## Battery & Solar Connections

| <b>Bulletin Type:</b> | TSB  | <b>Publication Date:</b> | March 2023                                     |
| <b>Bulletin #(s):</b> | 23-093   | <b>Make(s):</b>          | Jayco & Entegra Coach                          |

| <b>Incident:</b>                   | Battery and solar power connections installed to the secondary battery instead of the primary battery causing blown fuses.   |

Fig. 2

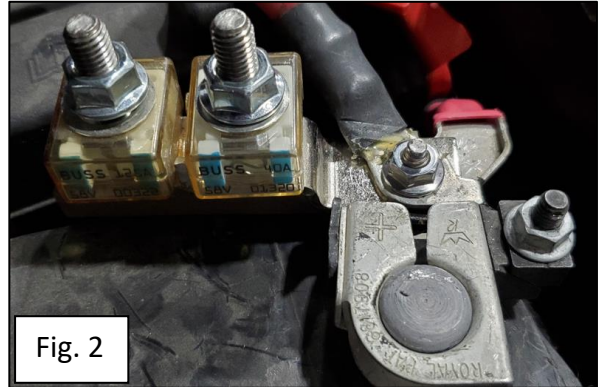
3. Install the previously removed fuse block on the driver side battery – positive lug with the Ford wiring. (Figure 2)
  - A. **NOTE:** Ford wire connector should be installed between the fuse block and the mounting nut.

Fig. 3

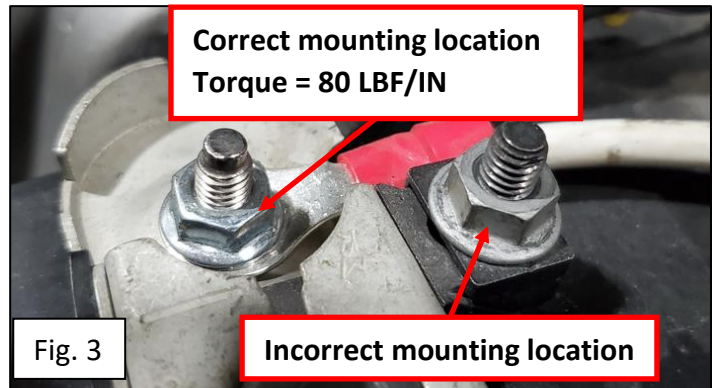
4. Verify the mounting location of the solar power wire on the negative lug. It should be connected directly to the lug as shown in Figure 3. If it is not, the connection will need to be moved and 6mm nut has been supplied.
  - A. Torque = 80 LBF/IN

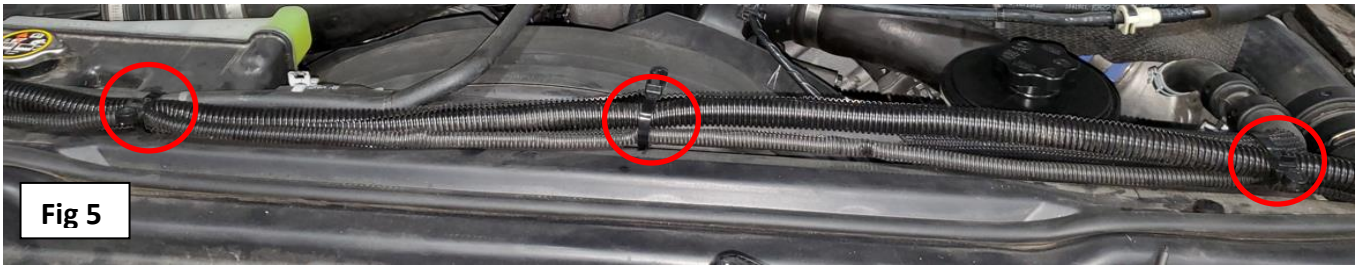
8. Route jumper harness from the isolator stud to the front of engine compartment, across the front and to the passenger side battery.

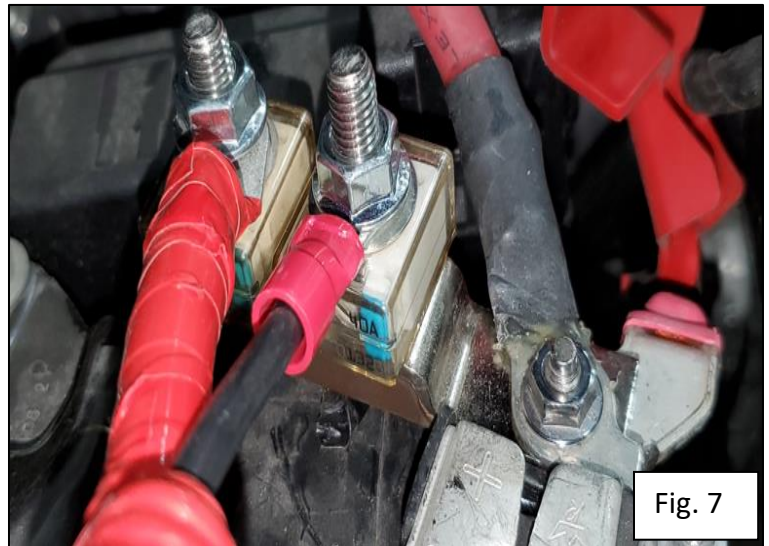
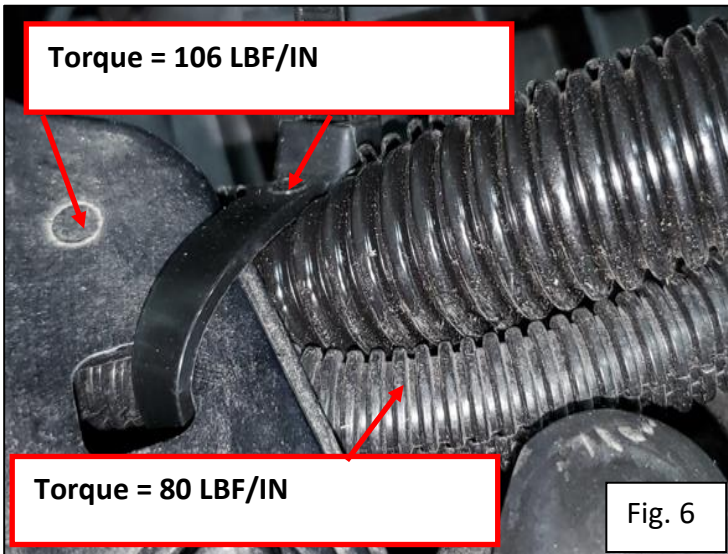
9. Secure the jumper harness with zip ties.
  - A. There should be a minimum of three zip ties securing the harness across the front. (Figure 5)
  - B. Install one zip tie in the passenger front corner. (Figure 6)
